Concerns: **EMWG 9500.0 and EMWK 9500.0**
all of the appliances produced before calendar week 05/13

Complaint: **Cooling fan starts up automatically after 10 minutes when the timer function is activated**

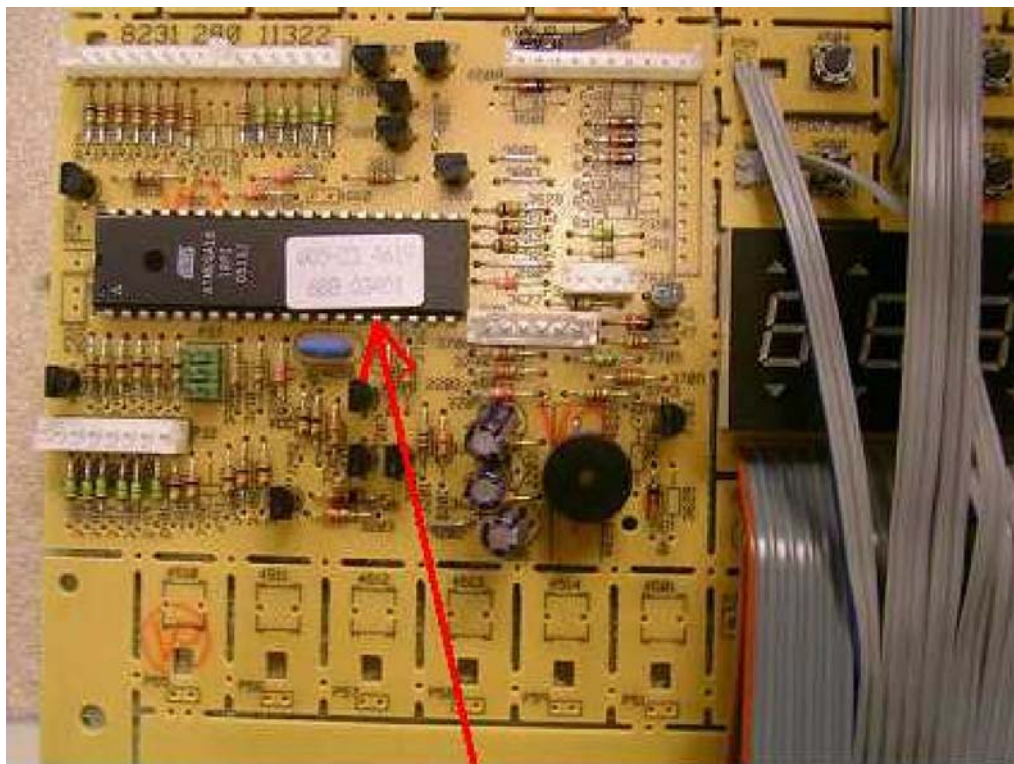
If the timer function is used for longer than 10 minutes, the cooling fan will start up automatically. In order to prevent this from occurring, the EEPROM of the KAG control circuit board, spare part no. 531 318, was provided with new software.

The new software version commences with the 05/13 production week in all of the control circuit board EEPROM's. The production date of the printed circuit boards can be seen above the label on the EEPROM.

In this example the production date of the printed circuit board is W05-23
(05 = year, 23 = CW 23)
